For the forgoing reasons, Busse Broadcasting Corporation respectfully requests that the staff reconsider its action and deny the Petition for Rulemaking filed on behalf of Citadel Communications Co., Ltd. to substitute UHF Channel 18 for VHF Channel 8 at Albion, Nebraska and allot VHF Channel 8 at Lincoln, Nebraska.

AFFIDAVIT OF JOHN P. ALLEN

ENGINEERING STATEMENT

The engineering data contained herein have been prepared on behalf of BUSSE BROADCASTING CORPORATION, licensee of KOLN(TV), Lincoln, Nebraska, in support of its Petition for Reconsideration in MM Docket No. 91-304

FIGURE 7-B
PROPOSED TRANSMITTER SITE
CHANNEL 18, ALBION
SMITH AND POWSTENKO

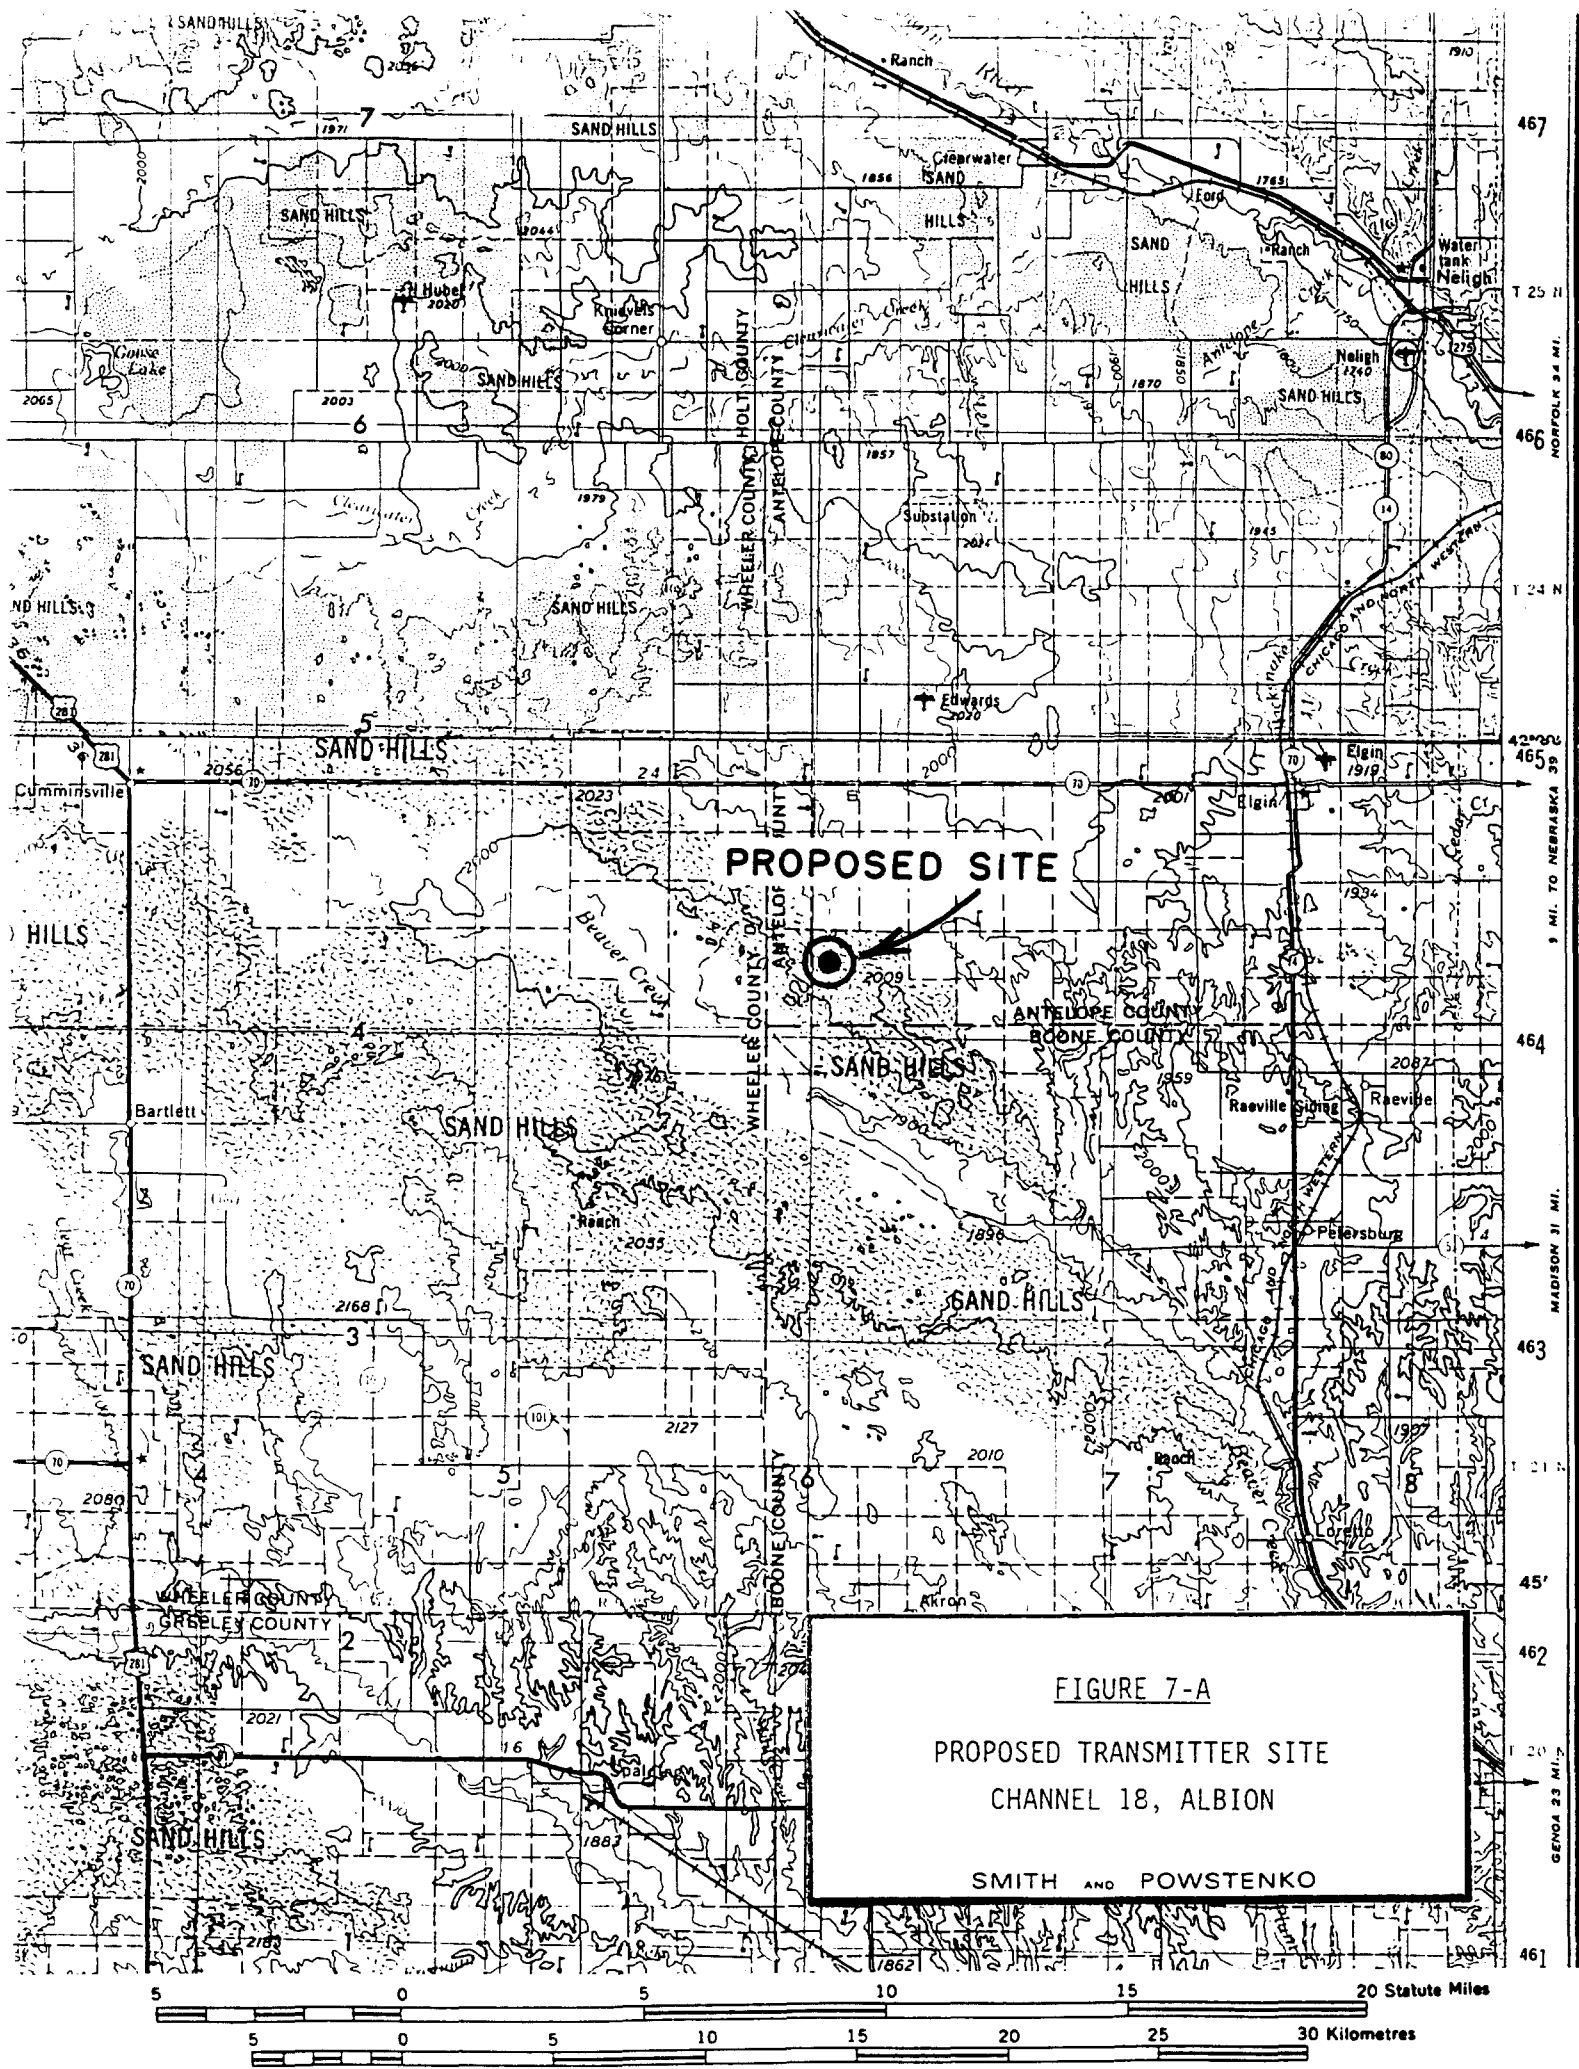
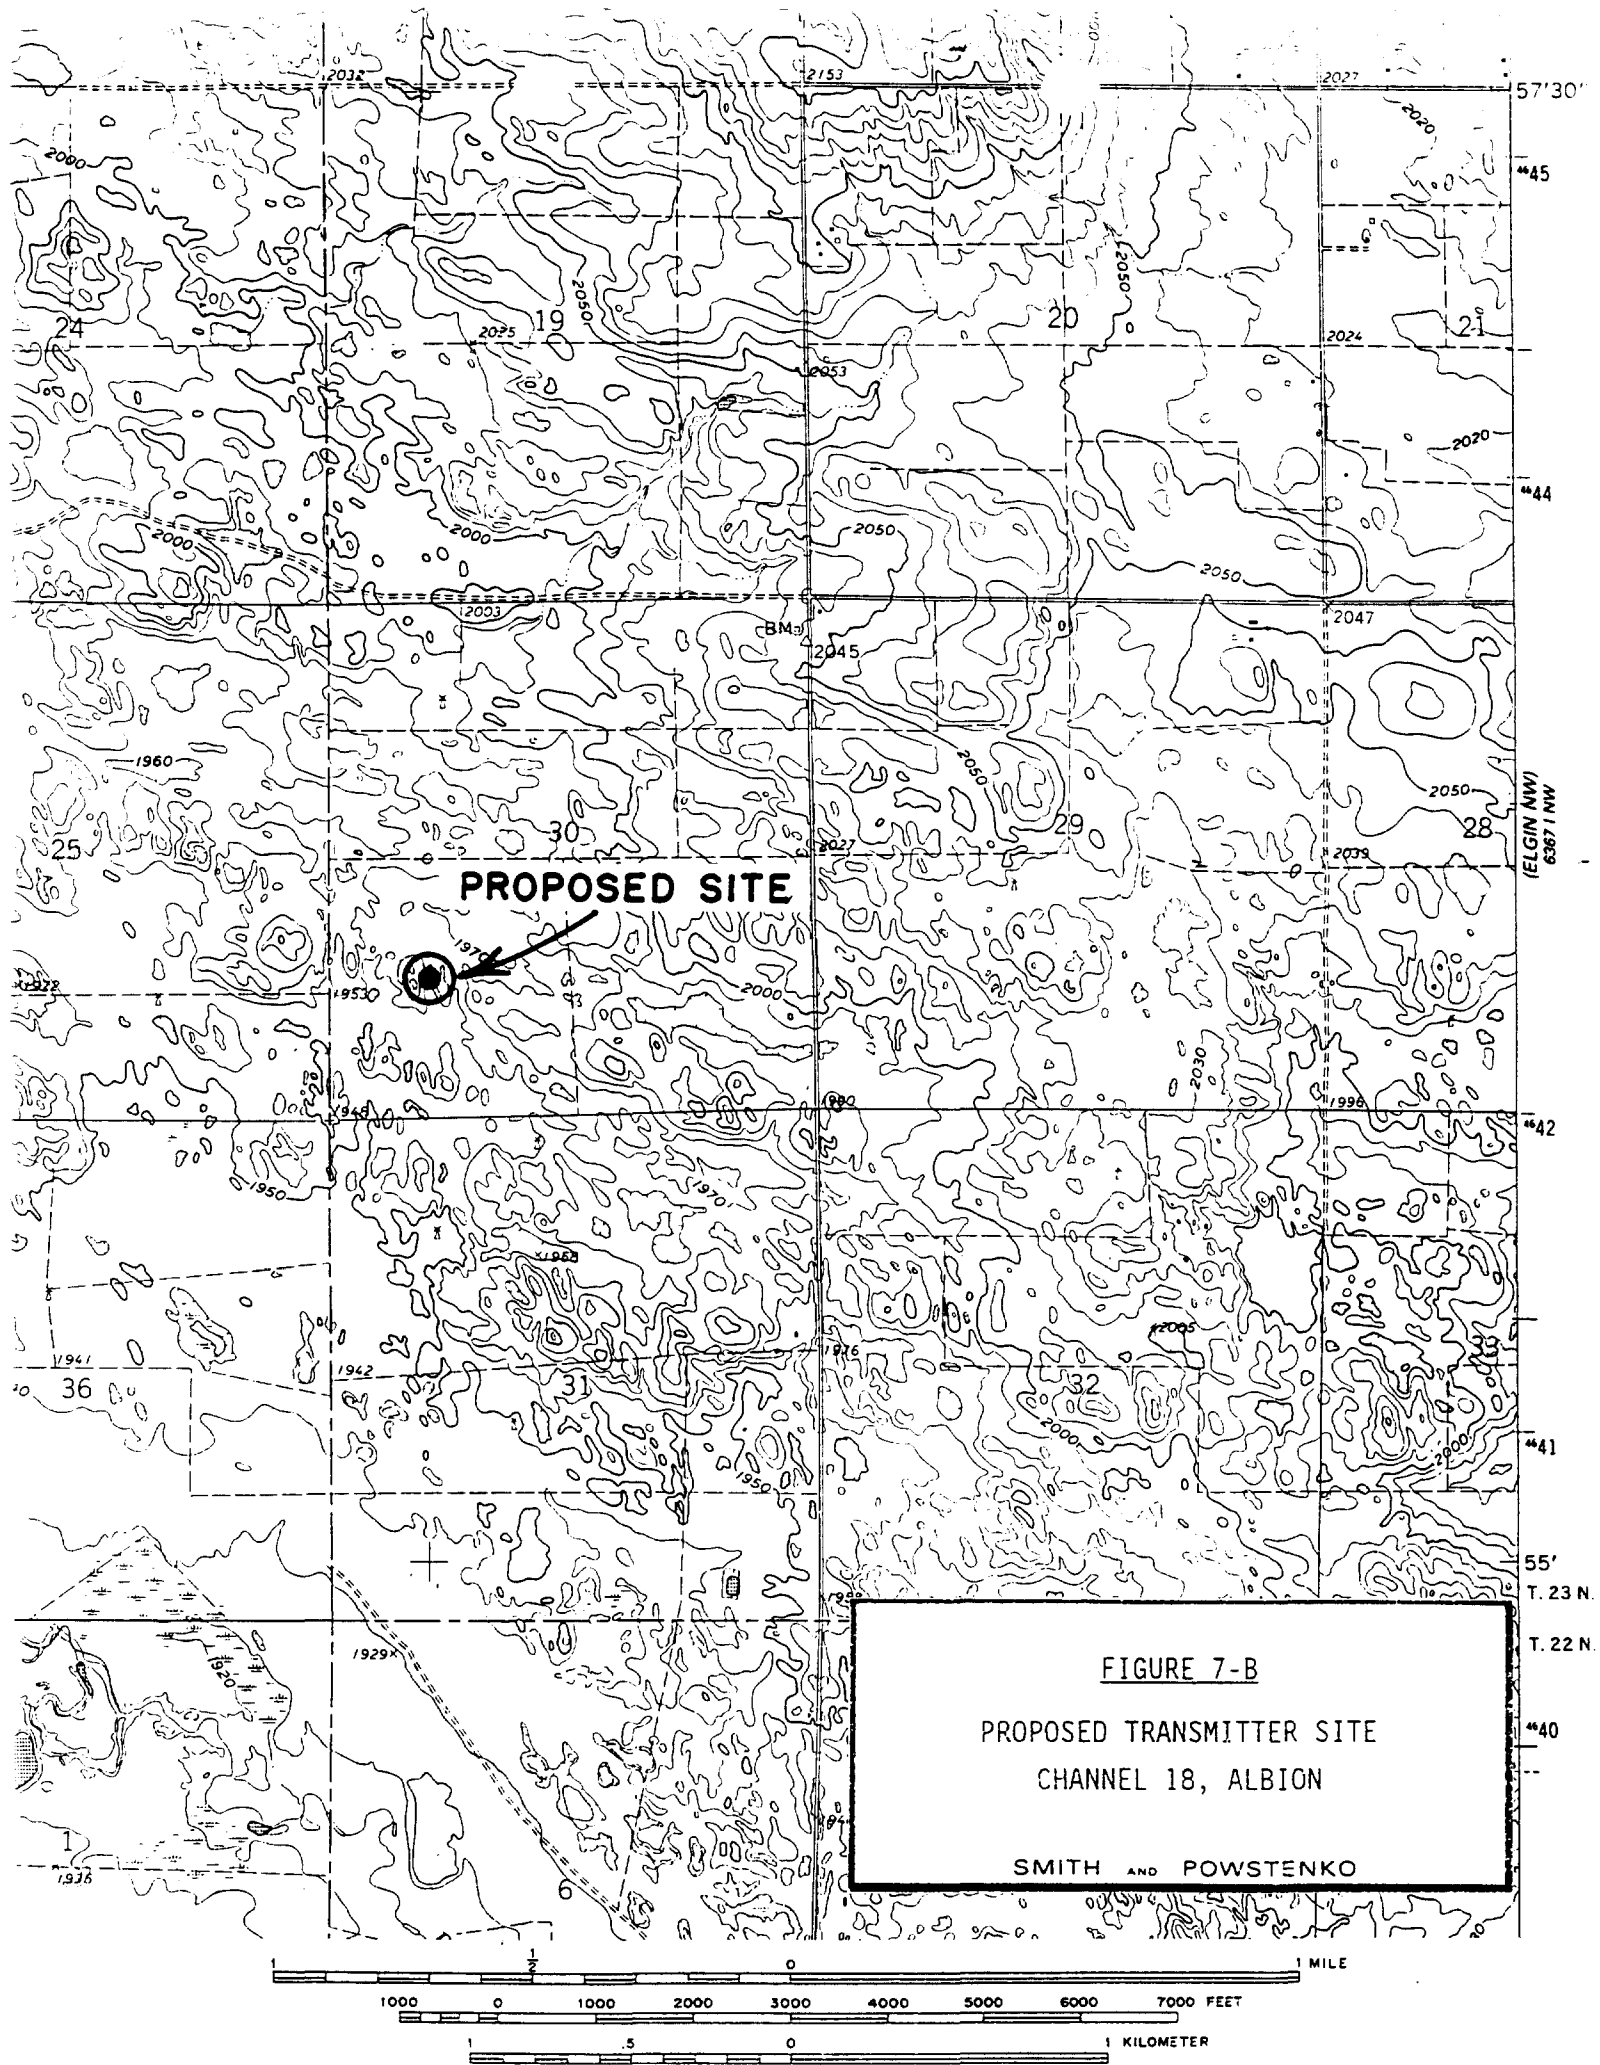
Finally, we come to the real-world question as to whether or not this scenario could ever be accomplished. In its petition Citadel specified geographic coordinates for its proposed Channel 18 facility but never discussed the nature of this particular site. Figures 7-A and 7-B are small- and large-scale topographic maps showing this site. As indicated, this general area is sparsely settled, and the specified site is quite remote. Even if FAA approval could be obtained for a tall tower at this location, there is no information at hand to indicate whether or not the site is accessible, primary power is available, there may be environmental problems, or, even that the property is indeed available for Citadel's purposes. Considering that the site is in an area of sand hills, ecological concerns might well prevent such construction.

FIGURE 8-A

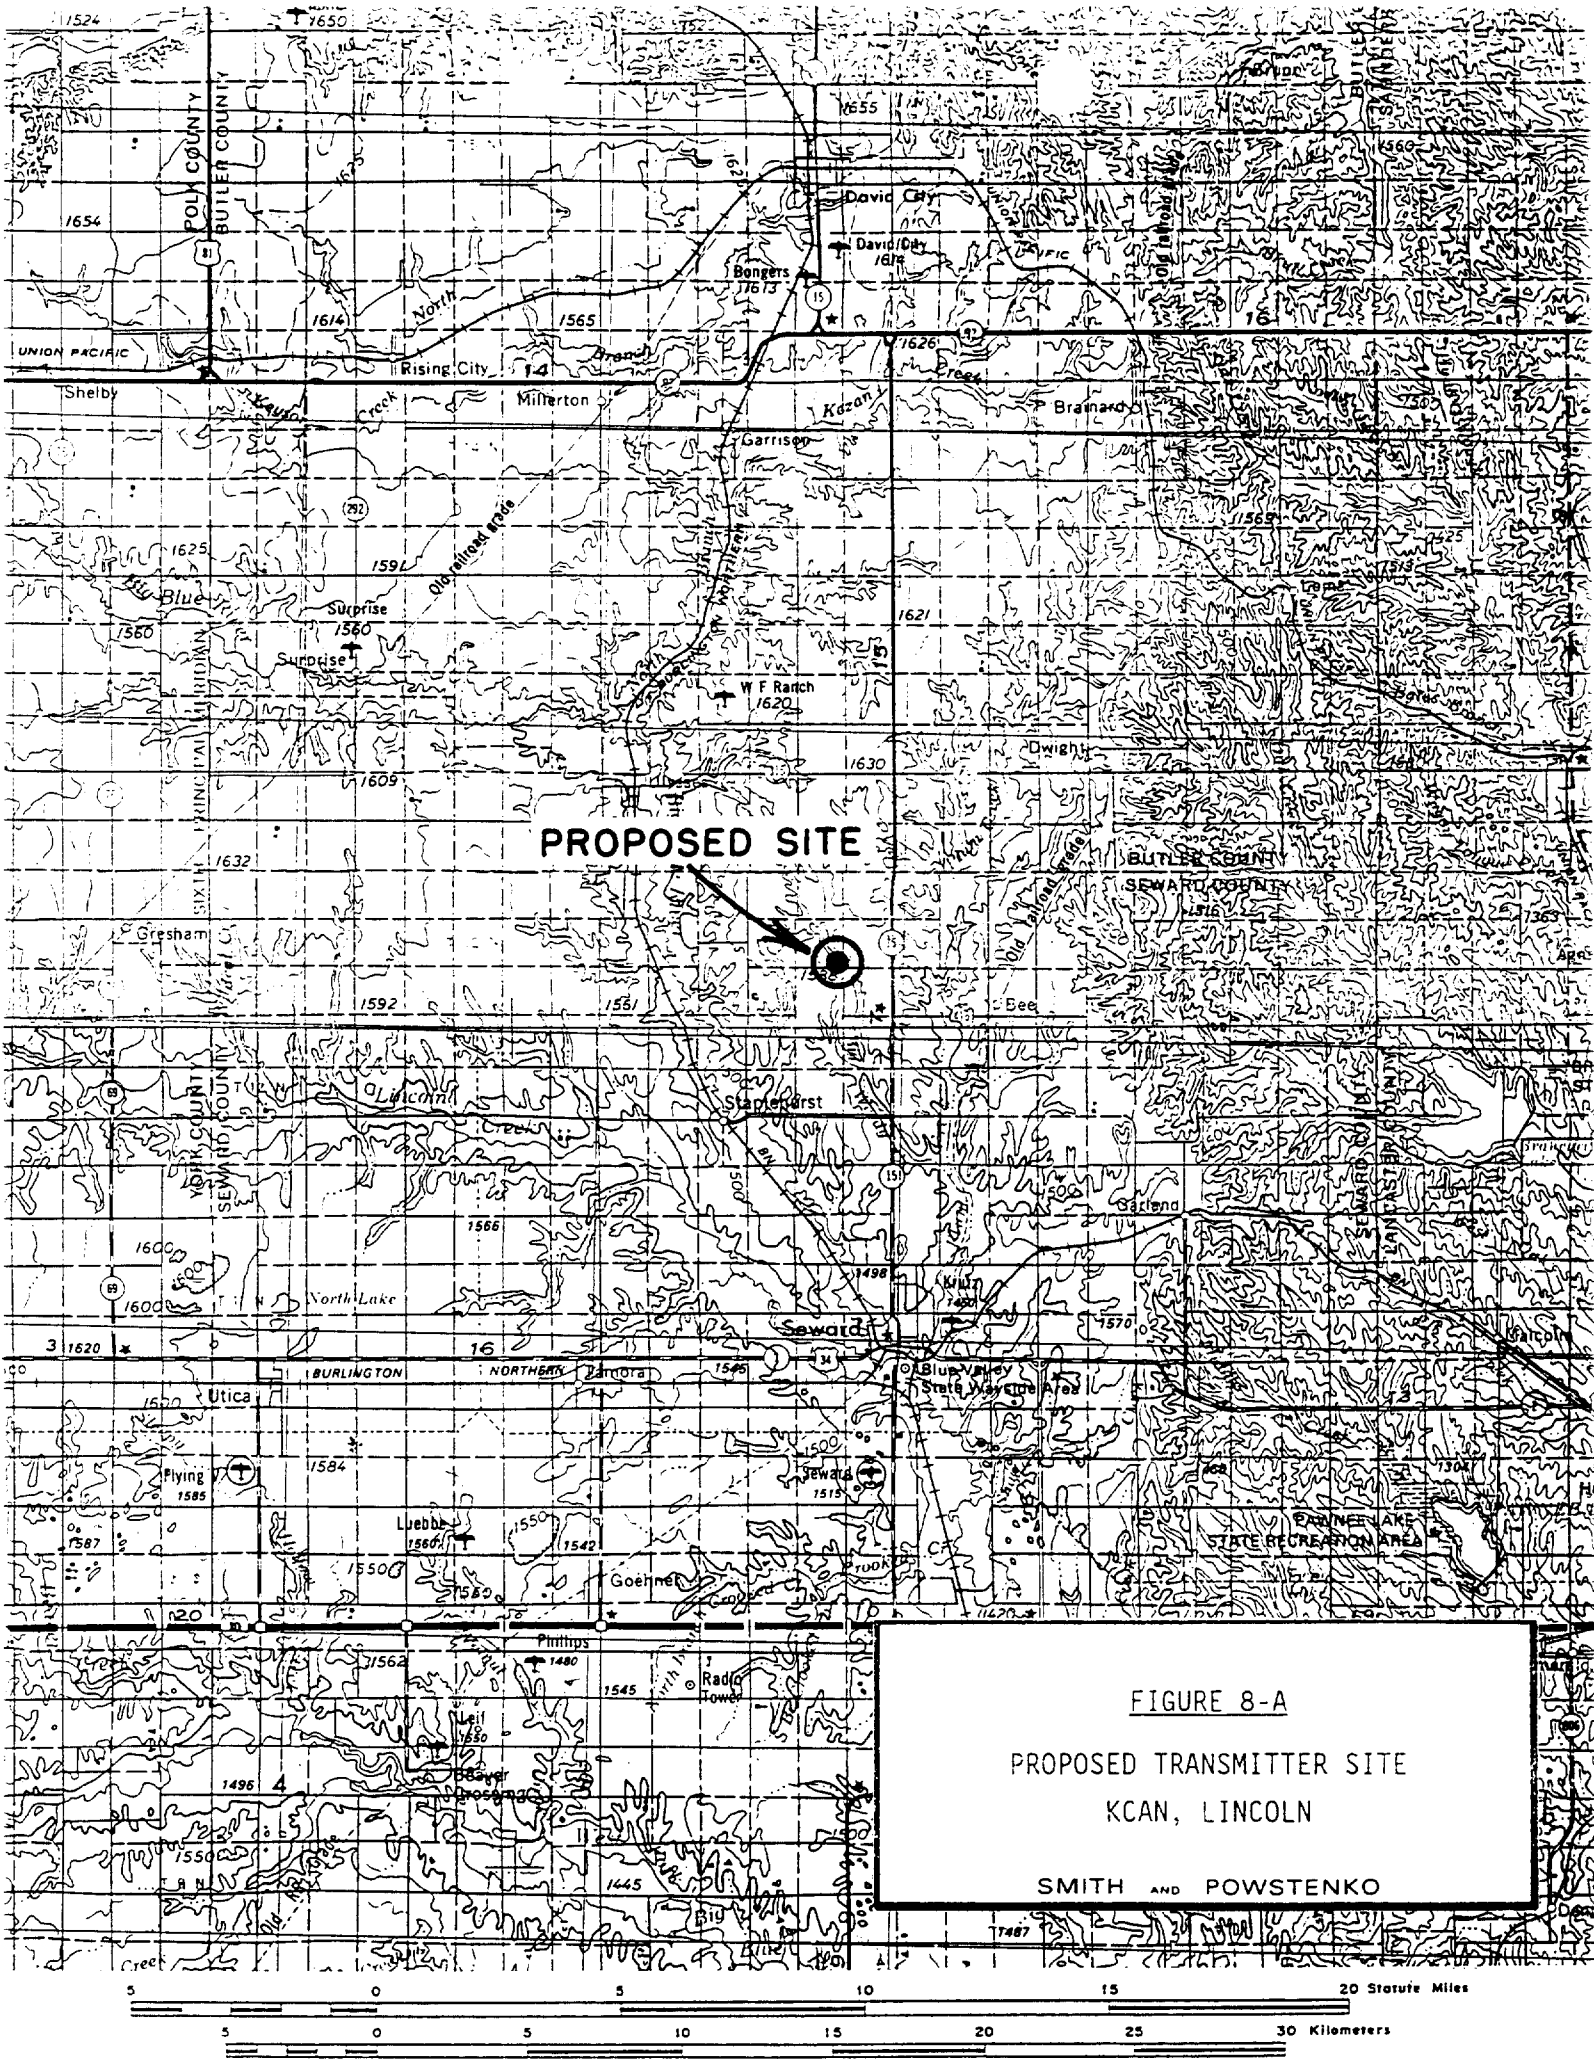
Similarly, in Figures 8-A and 8-B we have plotted the site that the Commission specified for the operation of KCAN as a Lincoln station. Although this area is less remote than the Channel 18 site, it is also in a relatively unpopulated area, and the same questions exist as to the practicability of constructing a television facility at this location. However, of greater significance is the fact that any proposal to erect a tall tower at this site would surely receive a Determination of Hazard from the FAA. Included in this pleading is a statement by the recognized aeronautical expert, John Allen, clearly demonstrating that a tall tower would not be

permitted at this location.
